03-2019 LATEST REVISION DATE APPROVED BY BRIDGE ENGINEER	 STANDARD DESIGN STEEL OVERHEAD SIGN TRUSS SEPTEMBER, 2011
	DMS RUNWAY GATE DETAILS
	SOST-14-11 50'-130' SPANS

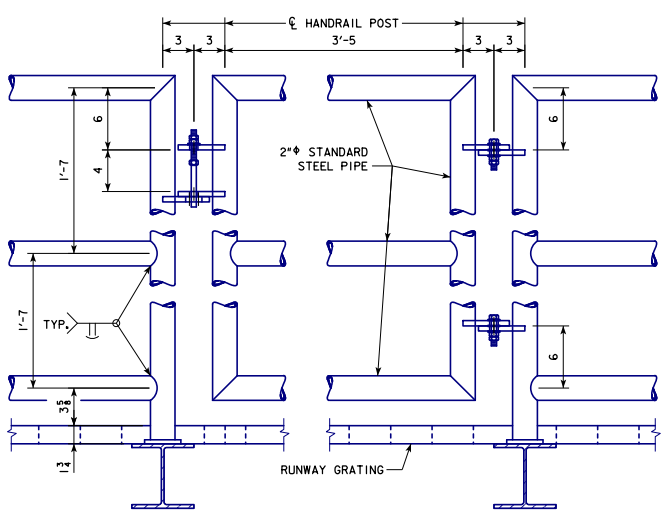
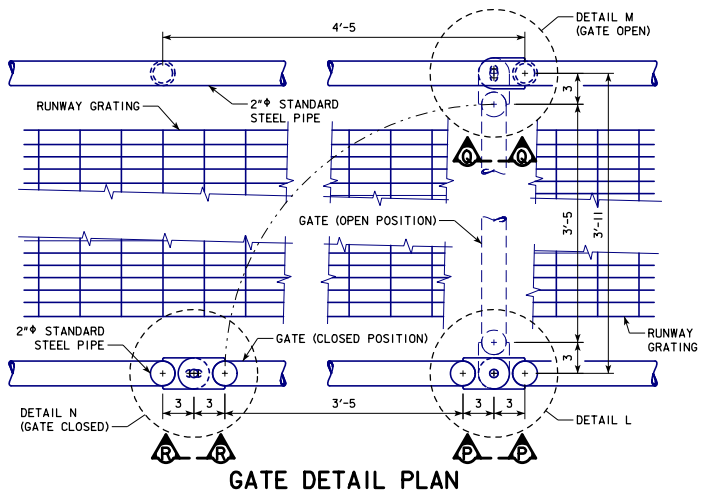
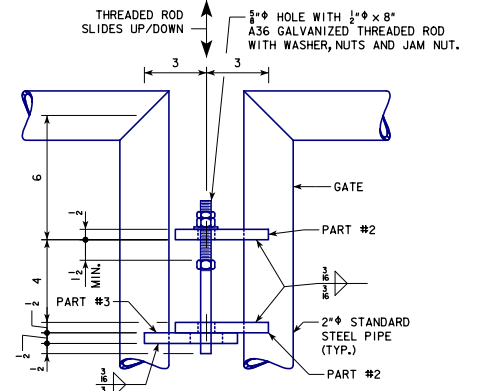
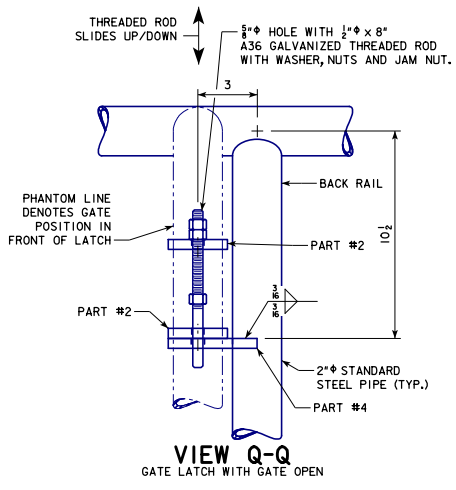
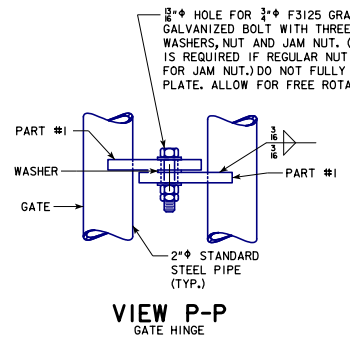
*REVISED 07-2017, CORRECTED WELD SIZE IN VIEW Q-Q TO 3/8" (WAS 1/2") TO MATCH THAT SHOWN IN OTHER DETAILS.
 *REVISED 03-2019, MODIFIED VIEW P-P FASTENER NOTE AND 1/2" ROD DESCRIPTION TO ADDRESS CHANGES IN ASTM SPECIFICATIONS. CORRECTED VIEW Q-Q CALLOUT FROM 2 1/2" x 1/4" TUBE TO 2" x 1/2" STANDARD STEEL PIPE.
 *REVISED 03-2019, MODIFIED FASTENER NOTE AND 1/2" ROD DESCRIPTION TO ADDRESS CHANGES IN ASTM SPECIFICATIONS. CORRECTED VIEW Q-Q CALLOUT FROM 2 1/2" x 1/4" TUBE TO 2" x 1/2" STANDARD STEEL PIPE.
 *STEEL OVERHEAD SIGN TRUSS.DGN - SOST-14-11 - THIS SHEET ISSUED 03-2013.
